REQUEST FOR INFORMATION **DATE:** September 01, 2016 **NO.:** RFI-267

Project Name: 15051-Webster University Interdisciplinary Science Building

Subject: URGENT RFI Floor sink conflict with footing

ACTION SYSTEM ROOM
137A

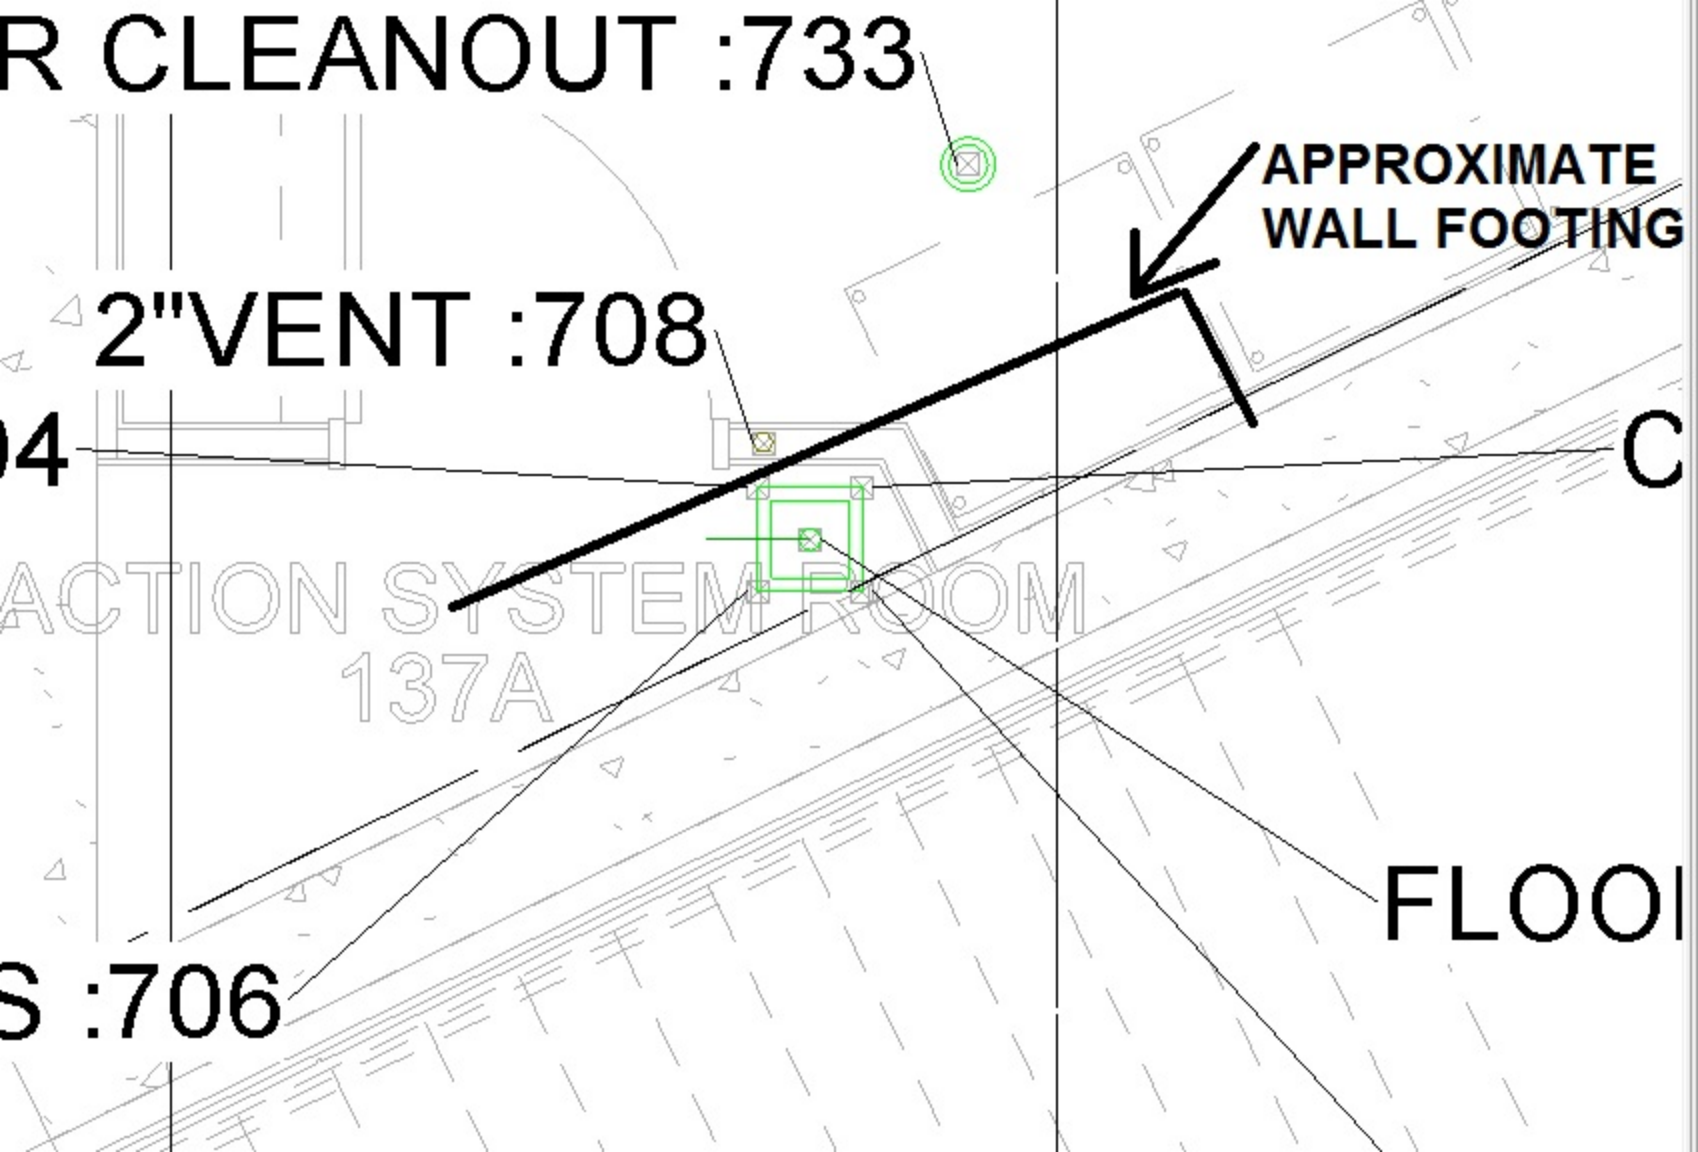
Level 01, Area B, Room 137A Preaction Fire protection closet

There is a floor sink shown on Sheet P0111.B. The location that the fire protection contractor needs (as indicated on attached screen shot) conflicts with the wall footing. If it is located any further West, it will be in the doorway, and also conflict with the overpour of column pad at A-1.6. The only 2 solutions we see are the following:

- 1) Delete floor sink and add in hub drain – if we use the current 2" vent stubbed up above ground in the stud wall and convert it into a hub drain, we could locate a p-trap under the floor, rise up in the stud wall with the hub drain, then offset above the floor into the room, and turn up with a 1/4 bend fitting inside the closet above the floor. The top of this would be approximately 7" or so above finished floor.
- 2) Shift North wall of closet North by at least 1'-6" – if the North wall of the room 137A were shifted North by 1'-6", it would provide enough room to locate the floor sink in the Northeast corner of the room.

For Option 1 above -

Based on the sketch provided 9/20, the proposed 2 inch diameter hub drain appears to under sized for the intended use and may present an over-flow issue. One possible solution would be to add pipe increaser, 2 x 4 inches, to the open hub drain and a 4 inch diameter pipe extended 24 inches above the finished floor. Another would be to extend the 3" drain under floor drain pipe up to above the floor as a hub drain, again with a drain 24" riser. Drainage would have to be regulated in any case to prevent the potential of flooding.

This RFI needs to be reviewed by the Fire Suppression contractor and Fire Suppression EoR. Based on their needs and experience, other solutions or options may be available and should be explored. Any solution arrived at will need to be fully coordinated with the FSC.
